**SUBJECT: NEW VEHICLE DEMONSTRATION / DELIVERY HOLD -
 Safety Recall 19S43 – Supplement #1**
 Certain 2019 Model Year Ranger Vehicles
 Rear Tail Lamps

New REASON FOR THIS SUPPLEMENT

CERTAIN 2019 MODEL YEAR RANGER VEHICLES — REAR TAIL LAMP WIRING

FIGURE 8

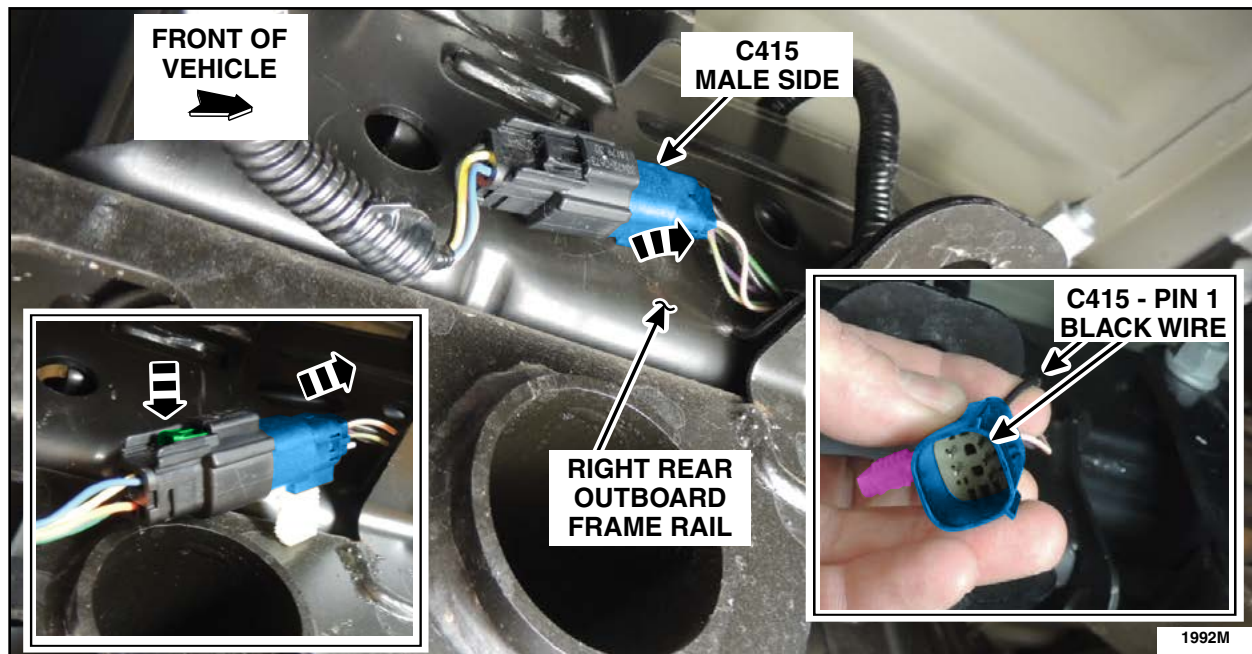
NOTE: Do NOT remove the rear lamp assembly for this test. Connector C415 is located on the outboard side of the right rear frame rail, and is accessible while vehicle is on the hoist.

8. Working from the rear of the vehicle, disconnect connector C415 (Without BLIS) located on the right rear outboard frame rail, **above the tailpipe**. Then Locate pin 1 (Black (BK) wire) **on the male terminal side**. See Figure 8.

FIGURE 9

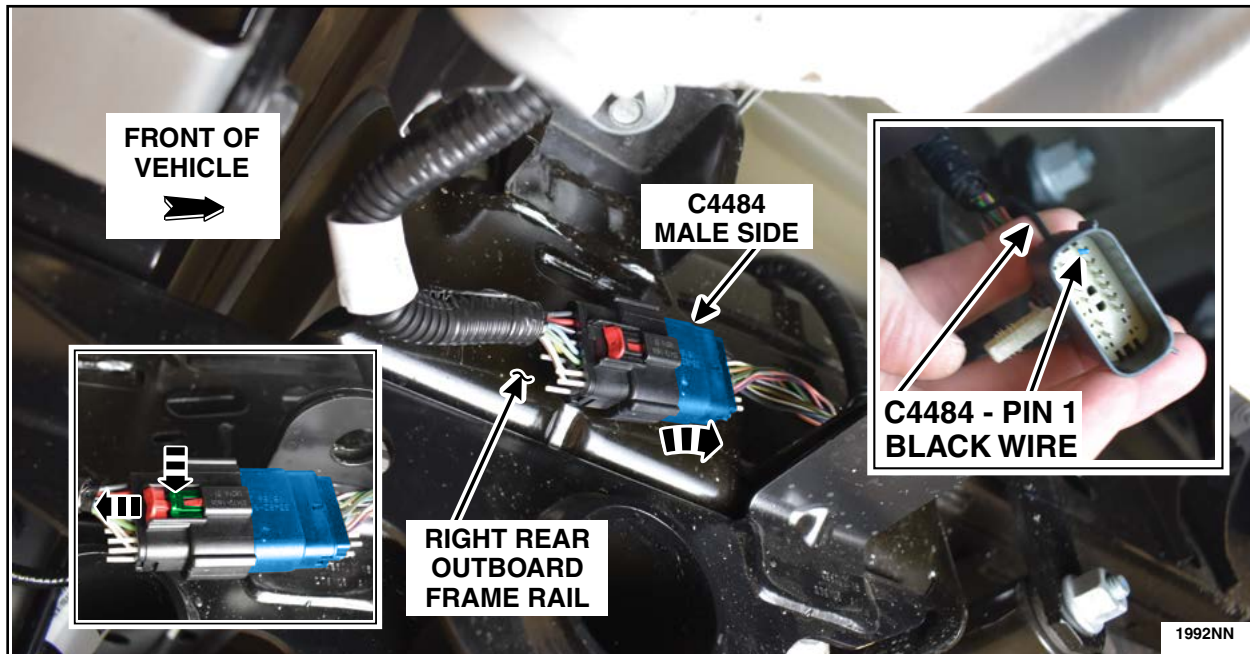
NOTE: Do NOT remove the rear lamp assembly for this test. Connector C4484 is located on the outboard side of the right rear frame rail, and is accessible while vehicle is on the hoist.

9. Working from the rear of the vehicle, disconnect connector C4484 (With BLIS) located on the right rear outboard frame rail, above the tailpipe. Then Locate pin 1 (Black (BK) wire) on the male terminal side. See Figure 9.
